Field Modification Tracking Table

Field Modification / Construction Bulletin Form	Date (dd/mm/yyyy):	07/31/12
Lower Passaic River Project, Phase I Removal	FM # or CB # (FM - ### or CB - ###):	CB-001
ARCADIS	Revision (##):	0

Lower Passaic River Project

TIERRA SOLUTIONS, INC. • LOWER PASSAIC RIVER, NEWARK NJ
PHASE I CERCLA NON-TIME-CRITICAL REMOVAL ACTION
OU-1 FLOODWALL TIEBACKS WALE MODIFICATIONS - (1 OF 3)

T-37 Lift-Off Test Report

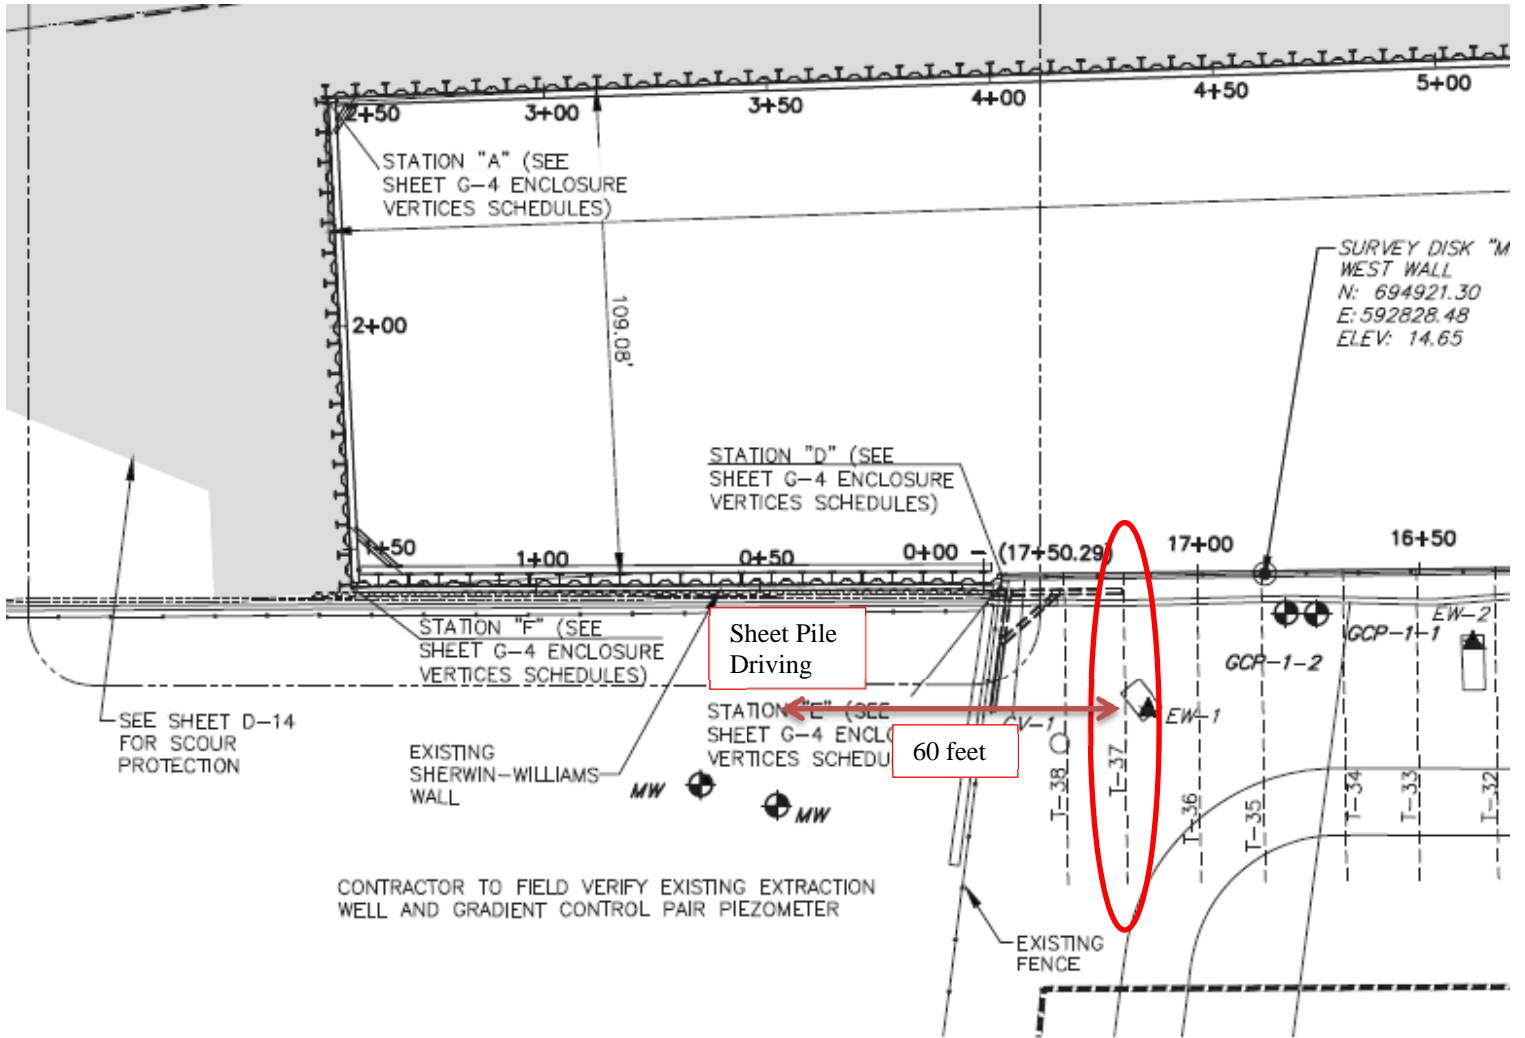
A change in load was noticed on 4/16/2012. The anchor relaxation was potentially caused by a sheet-pile driving operation that began on 4/16/2012 in the adjacent Sherwin-Williams property. The sheet-pile activity was being conducted approximately 60 feet away from anchor T-37. The loss in load from the 90 kip lock off load to 70 kips occurred on 4/16/2012, exactly when they began driving sheet piles. Observations were made at the anchor head, and no defects were noted, which ruled out the possibility that the barge caused the anchor damage.

On 6/12/2012 Nicholson mobilized to the site to perform a lift-off test on anchor T-37. This was 50 days after the initial loss in load was noted. During the initial lift-off test, a load of 60 kips was noted. The anchor load was brought up to the design load of 150 kips, and then locked off at 92 kips, which required the placement of a ¼" shim being the anchor head. A final lift-off test was performed on the anchor, which confirmed that the anchor was brought back to the 92 kip load with the use of an additional shim. The total shim count under the anchor head is currently 3-¼".

Lift-Off Test Date	6/12/2012
Load on anchor during initial lift-off test	1220 psi, 60 kips
Max load during lift-off test	3400 psi, 150 kips
Final lift off load and new lock off load	2050 psi, 92 kips

Added a ¼" shim under the head to achieve the above results.

Total shims under anchor are currently 3.25" (one 3 inch and one ¼ inch)

(A) SECTIONAL PLAN - ELEV 5.0

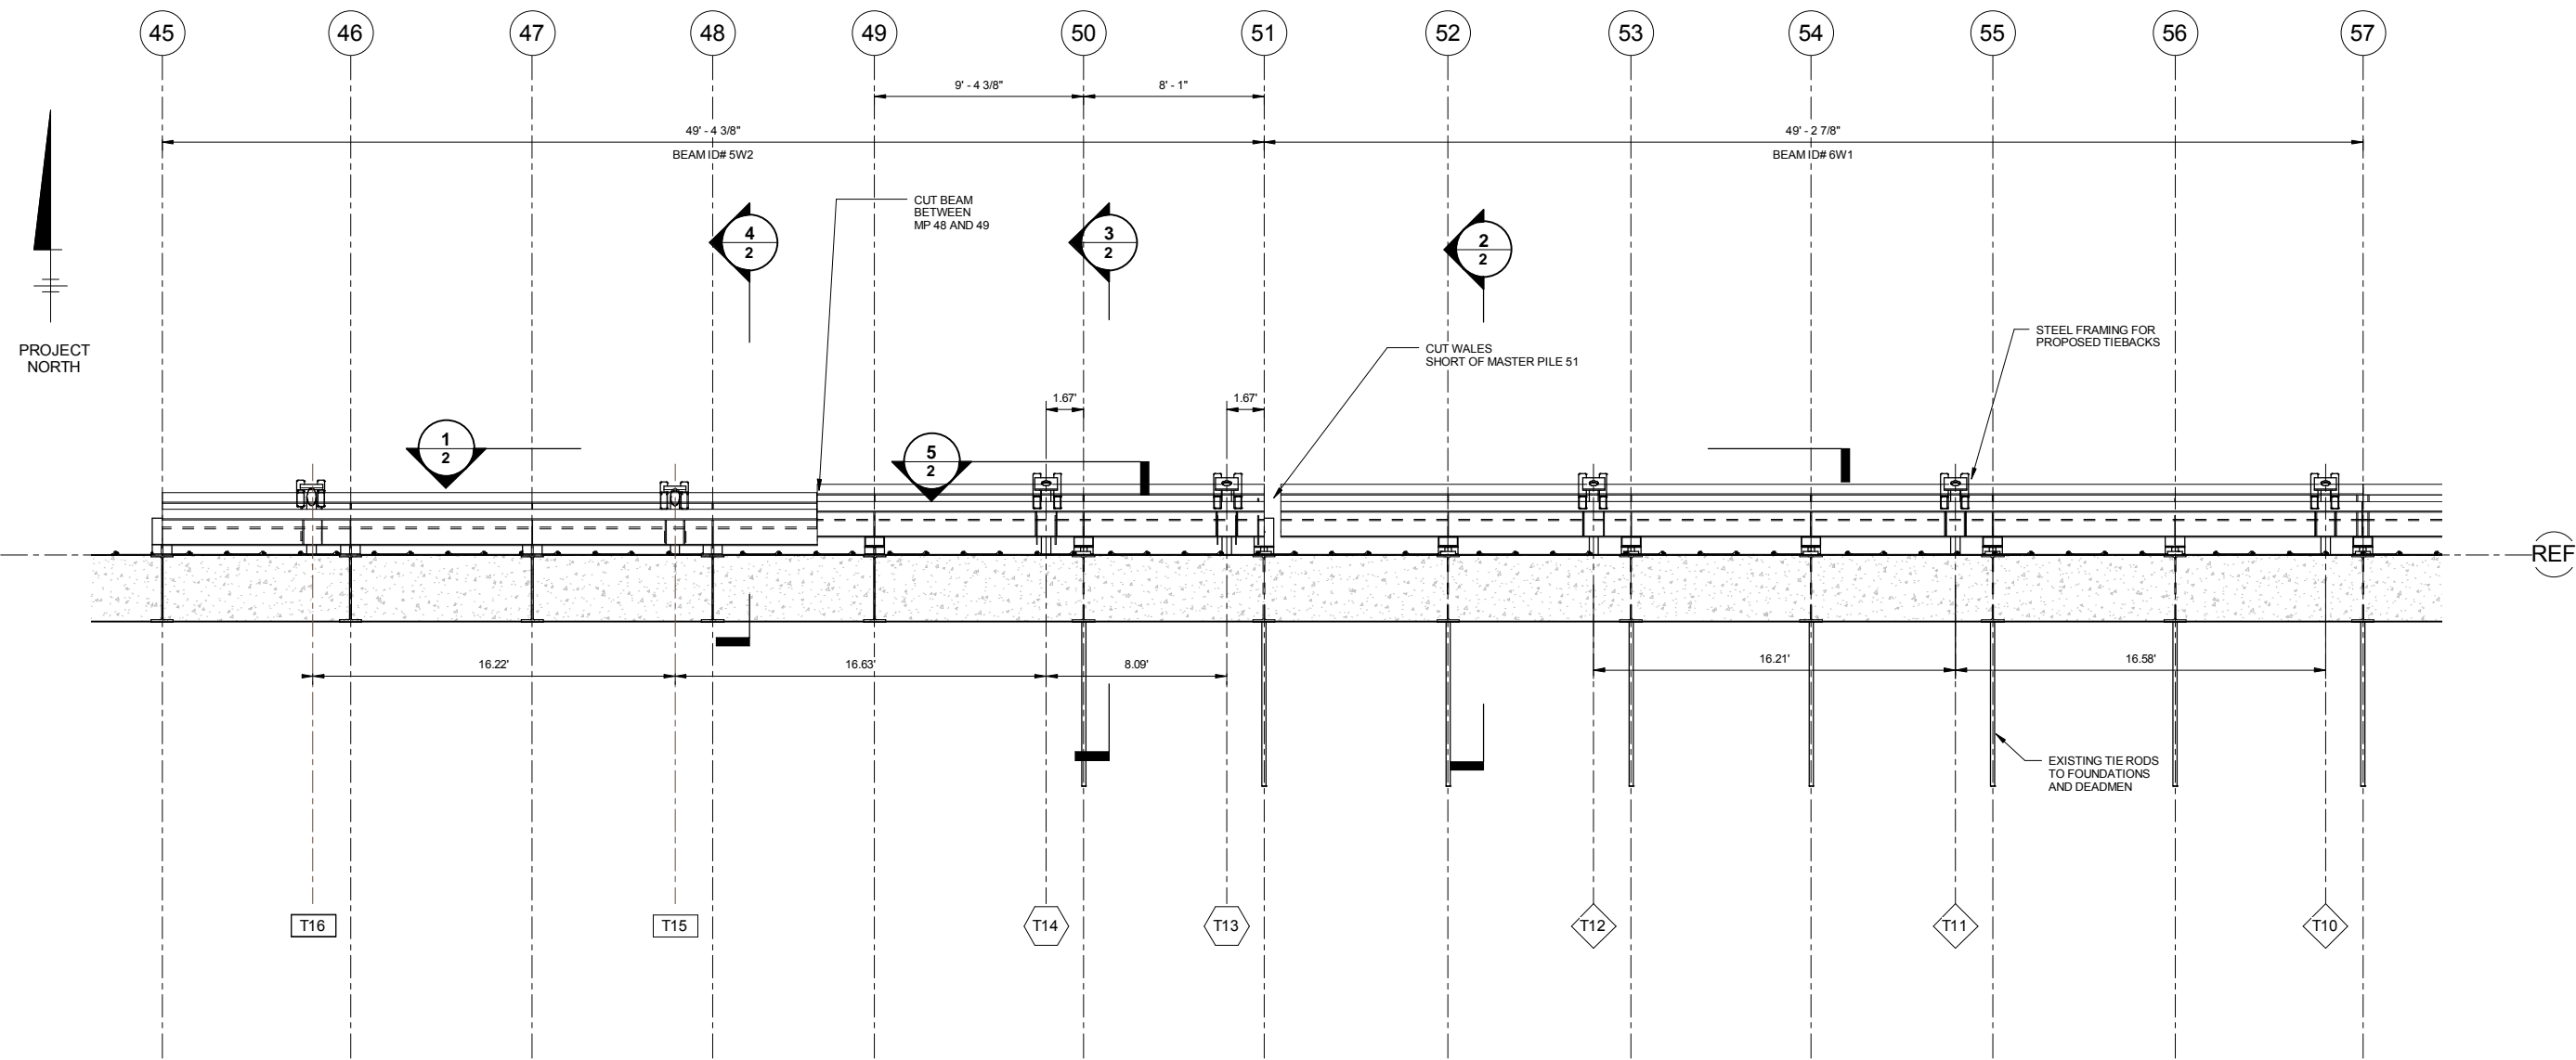
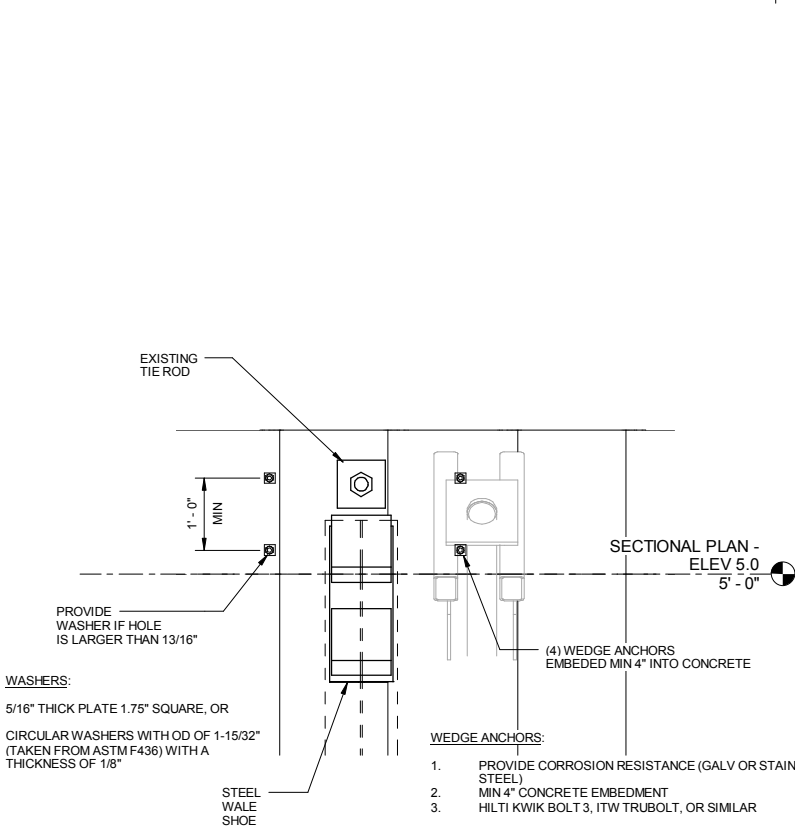
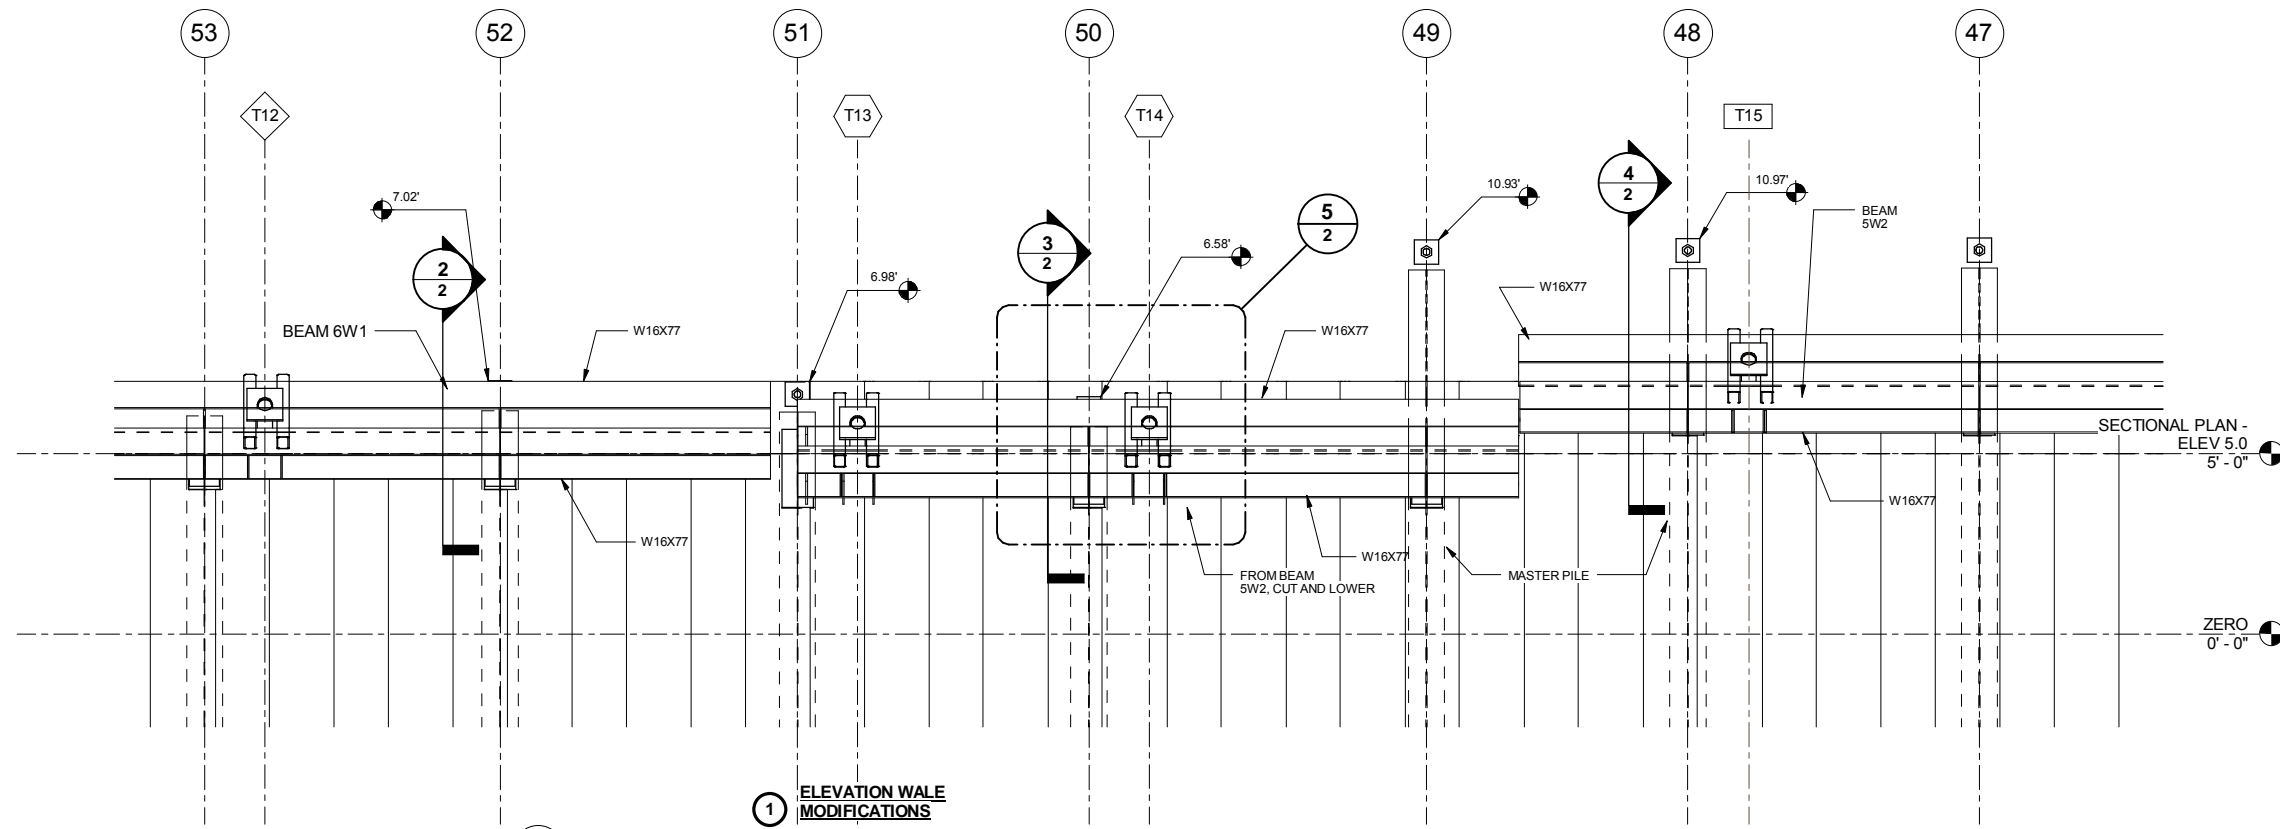
Reason for and nature of modification: FM-001 includes the following modifications:
 1) Placing wedge anchors to existing AS 500-12 flat sheeting where cutting of bolts and sheeting (at existing Master Piles) caused existing sheets to pull away from OU-1 Floodwall;
 2) Placing steel shims at master pile locations (as needed) to account for deformation in existing AS 500-12 flat sheeting which occurs between master piles which impeded tieback wale installation; and
 3) Adjusting the elevation of the proposed tiebacks due to field surveyed locations of existing tierods/master piles which impeded tieback wale installation and to minimize the need for steel shims indicated in 2) above.
 Details for the above modifications are provided in the attached Drawings 1 and 2.

SEDIMENT CONTROL DETAILS FOR TEMPORARY STOCKPILES OF EXCAVATED MATERIAL

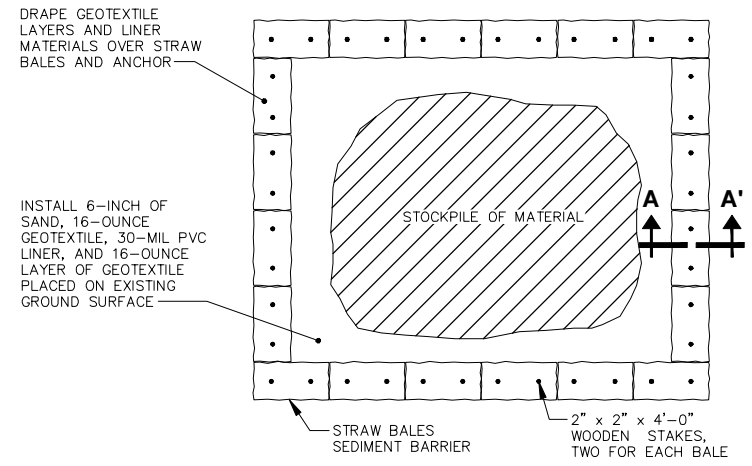
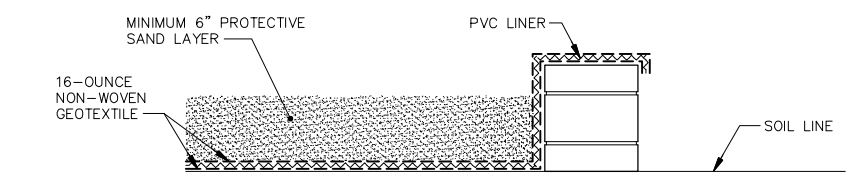
Based on a review of project specifications specific to the 6-inch protective layer within the stockpile areas, Abscope requested a change in materials specified from sand to DGA for the 6 -inch protective layer within the stockpile. Results in cost savings (unit cost for DGA< sand). ARCADIS design and Construction engineers agreed via email to this change during mobilization. This change needs to be addressed via a field modification to complete the submittal process.

CATCH BASIN (TYPE B) COVER PLAN

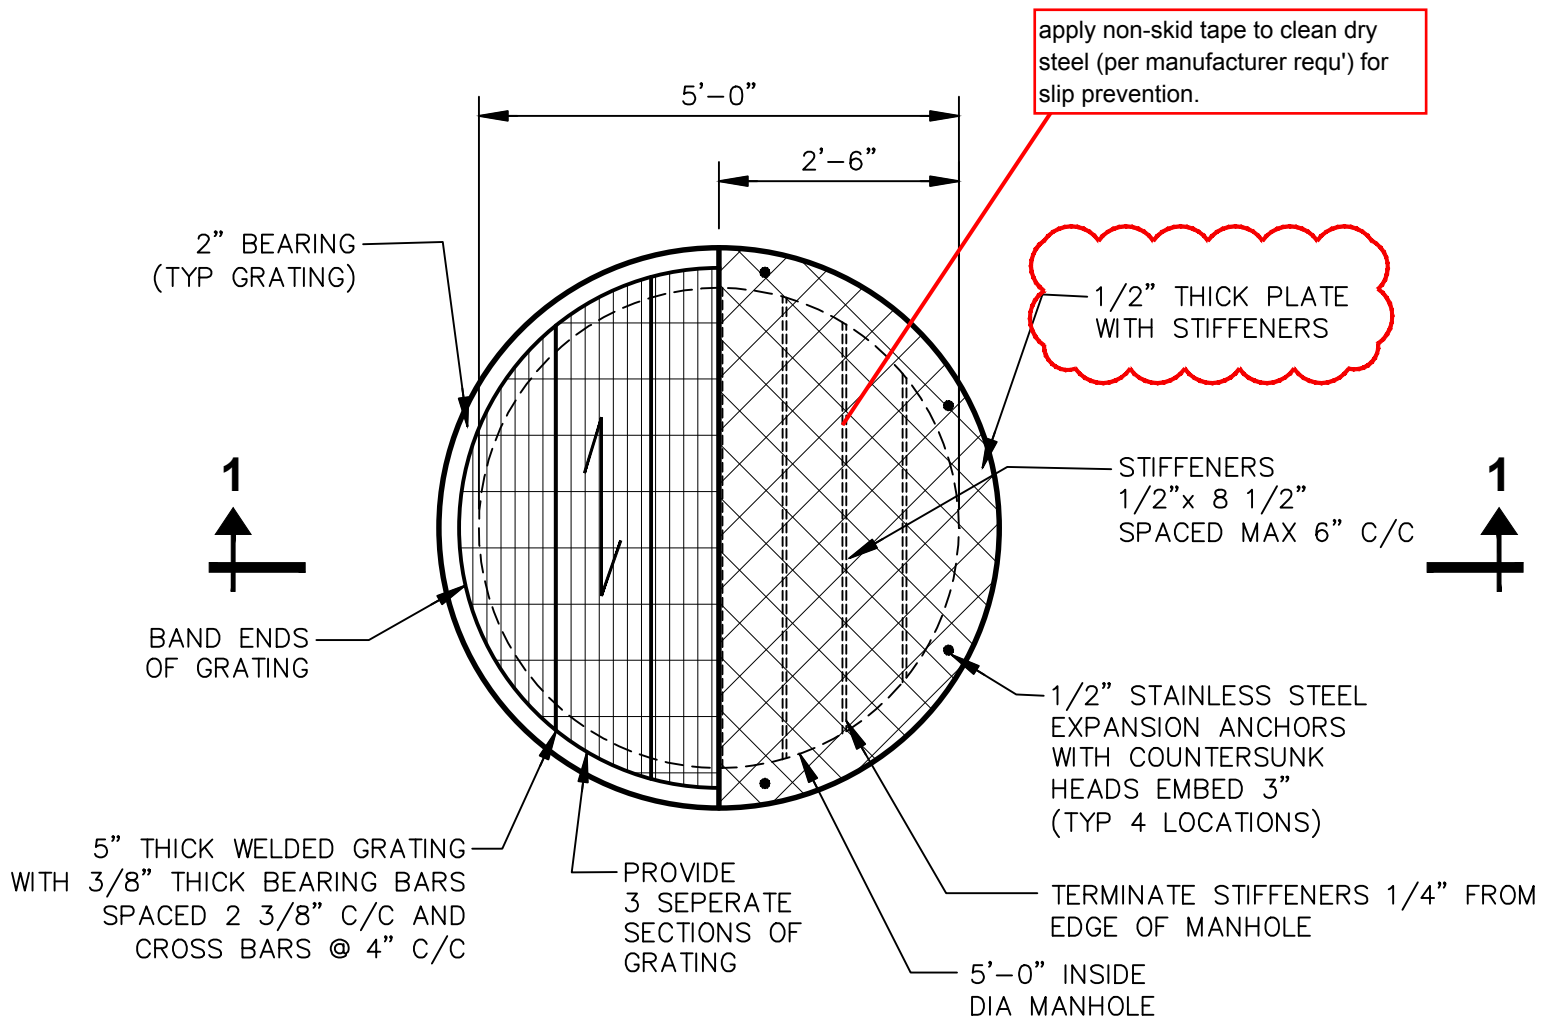
Abscope requested a modification to the Type-B catch basin lid design to change the solid lid material from 5/8-inch checker plate when they determined the material was not readily available and would have an increased cost. ARCADIS evaluated options and selected a modification to 1/2-inch solid plate w/anti-skid tape on the lid following completion of structural calculations.

Are sketches detailing design modifications attached to FM?	Yes / No	Date
Are existing drawings required to be updated, sealed and re-issued? <small>(note - as-built drawings will be issued after construction and will incorporate FM)</small>	Yes / No	9/6/2011
Do the specifications need to be modified?	Yes / No	
Specific drawings and/or specification sections and paragraphs affected: <u>Revised detail on S-23</u>
